SITE SOURCE CONTROL (SSC) WORK PLAN ADDENDUM NO. 4

GM BEDFORD REMOVAL ACTION BEDFORD, INDIANA

JUNE 2005 Ref. no. 13968 (116)

PLAN 1 SEEPS AND SPRING LOCATIONS

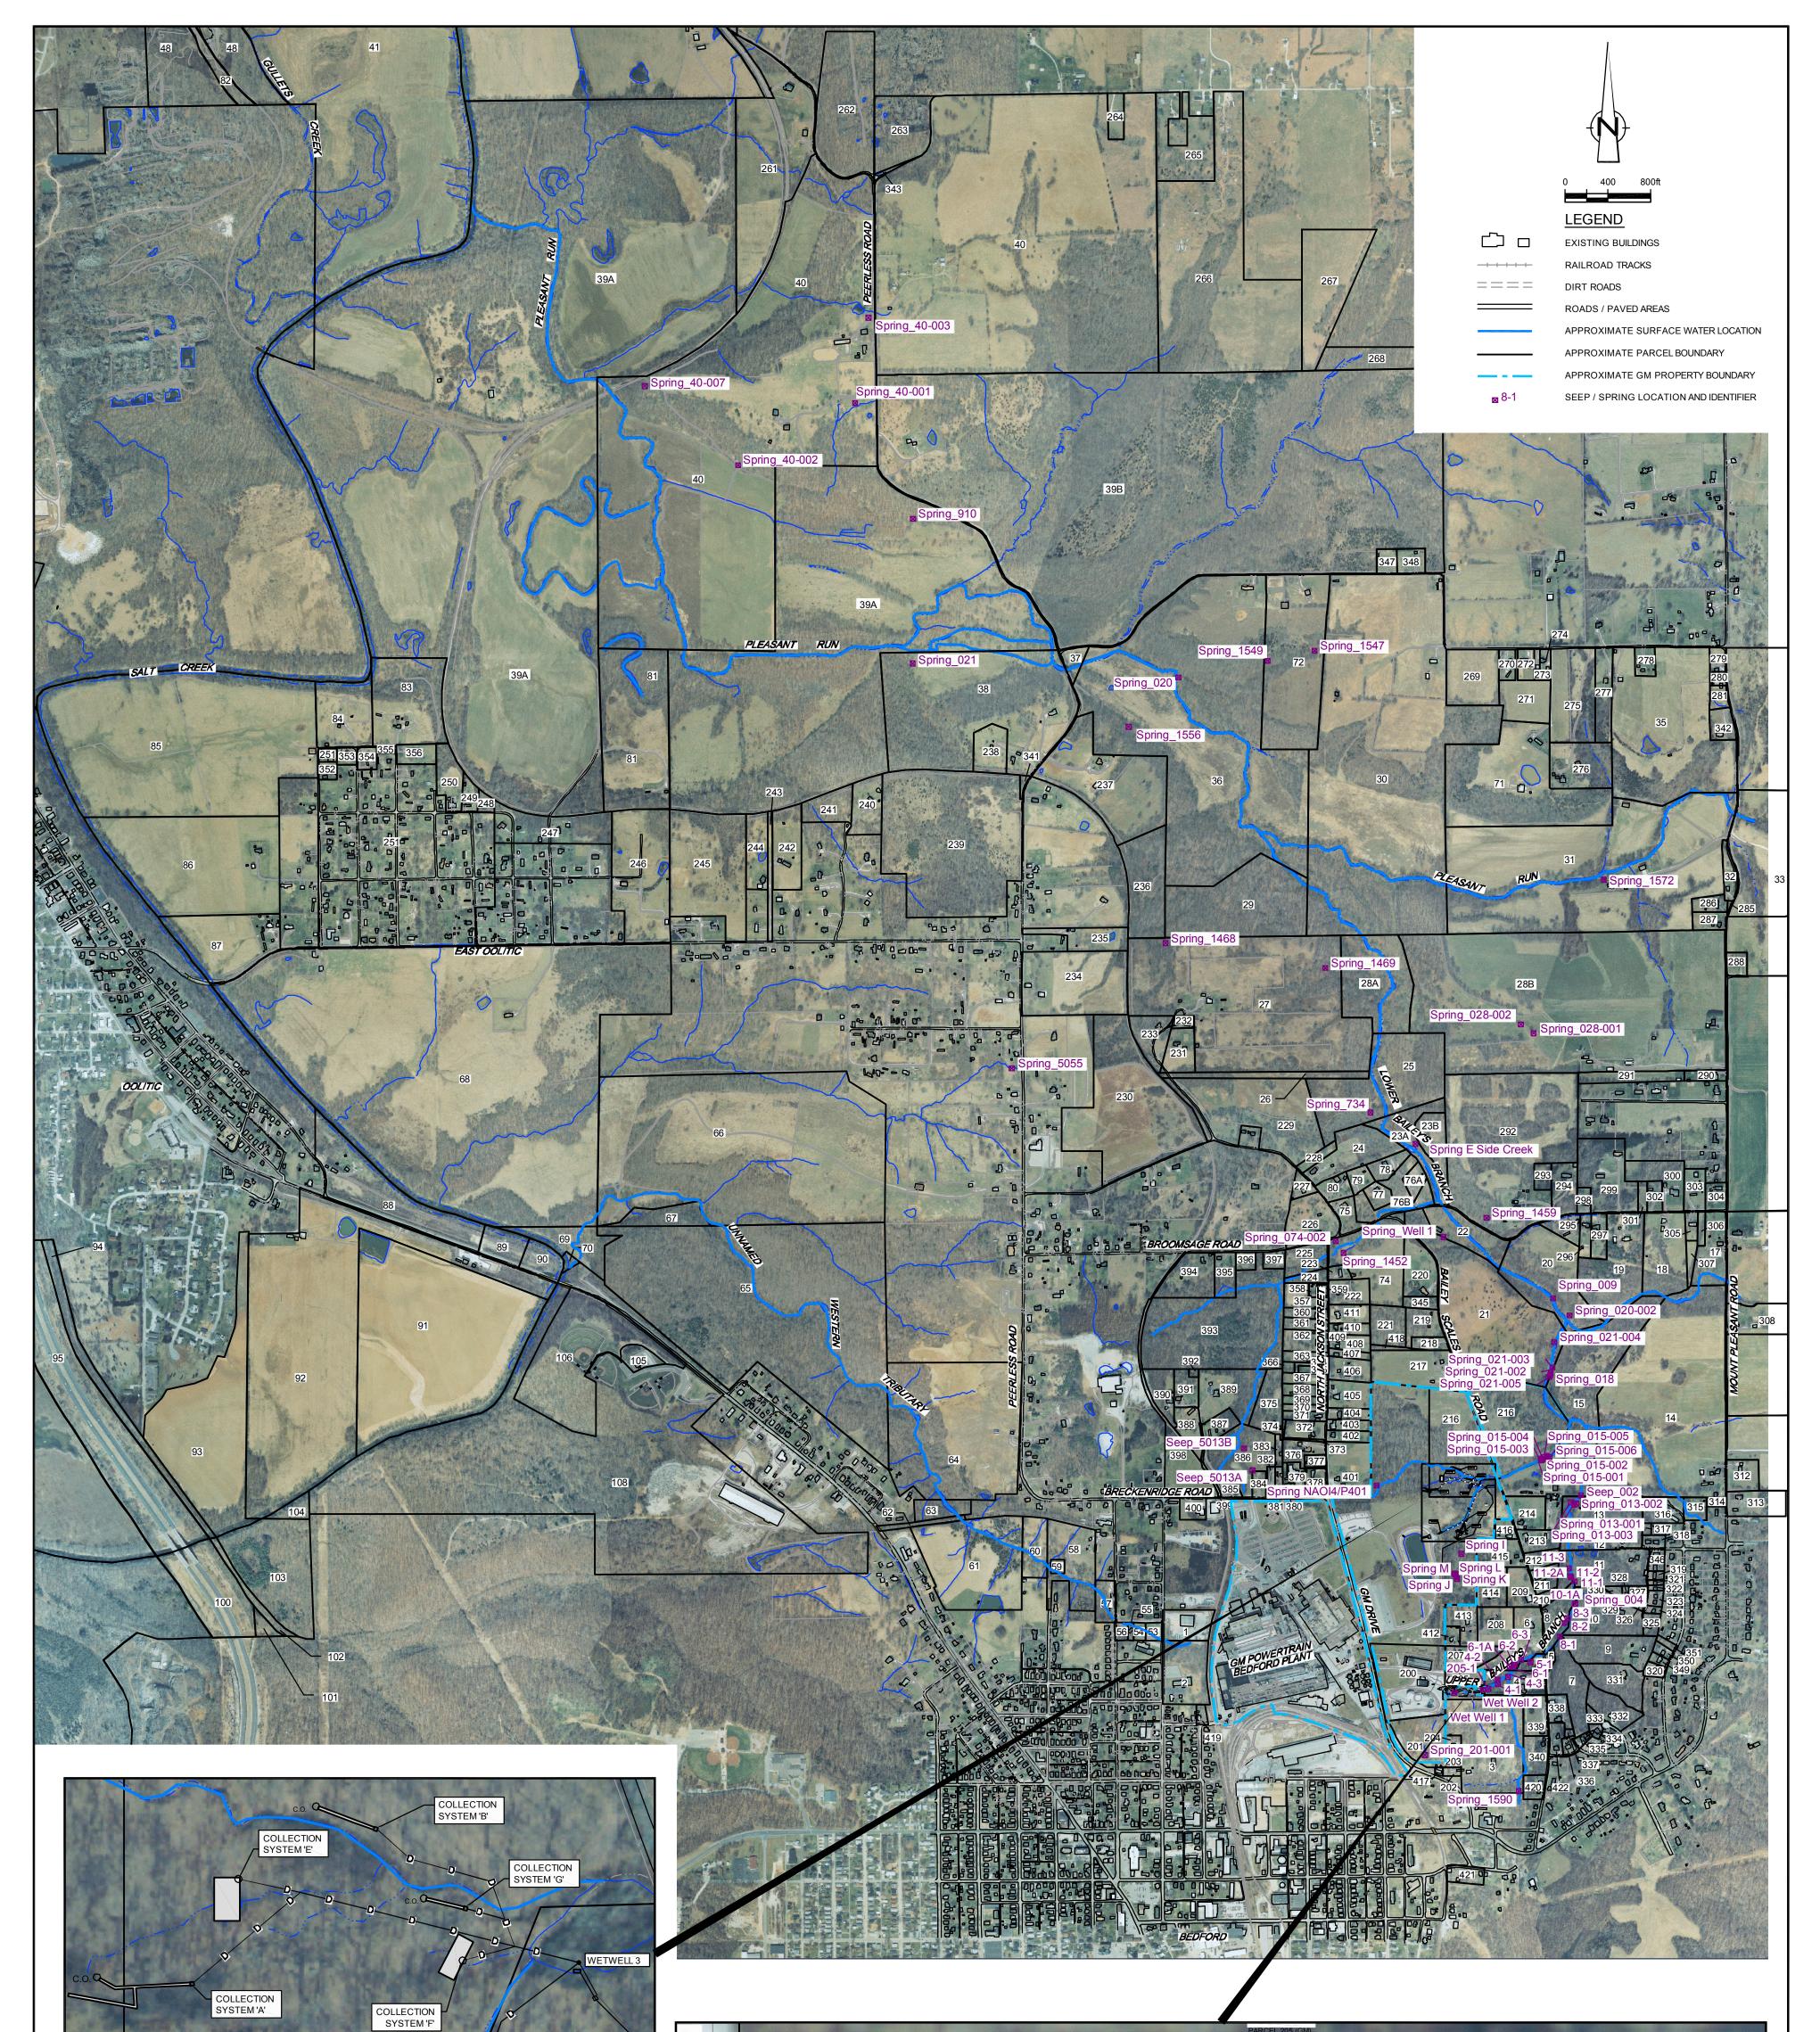
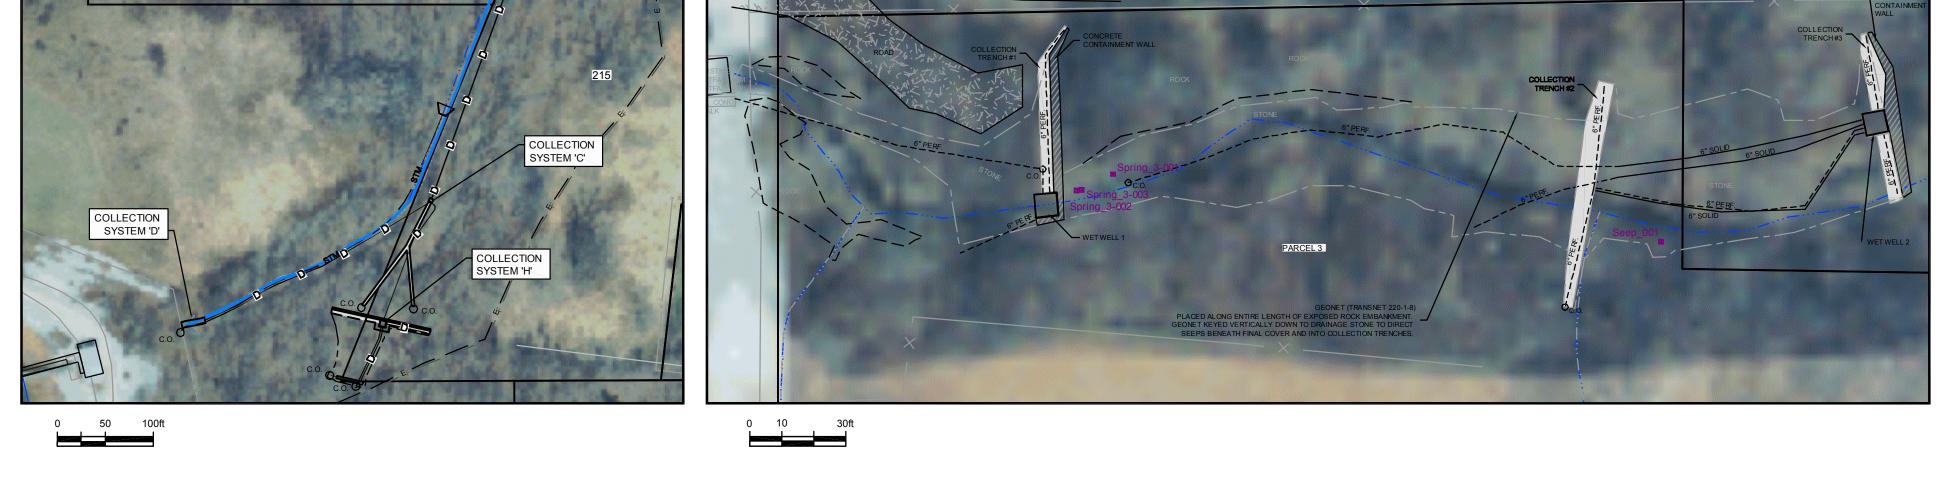
- <u>Spring 4007</u> The actual location identification should be, "Spring_40-007";
- <u>SW-X243Y232</u> This is actually a sample identification for the surface water sample collected at the spring location, "Eastern Seep Area 01" and not a seep or spring. There is only one spring at this location, which is Eastern Seep Area 01;

- <u>SW-X256Y260</u> This is a sample identification for a surface water sample collected at this location. There is not a seep, or spring, at this location; and

- <u>Seep_5013</u> This spring was inadvertently omitted from the list. It was also discovered later in the monitoring program that there was another spring located near Seep_5013 and that the field personnel had been checking the second spring, rather than the original location. These springs were subsequently renamed as Seep_5013A (the original spring) and Seep_5013B (the spring the field personnel were checking).

The following sections summarize which seeps and springs were included for each sampling event. Summary tables and results describing each of these sampling events are presented in the Site Source Control – Seep and Spring Data Package. Plan 1 presents all of the currently identified seeps and springs.
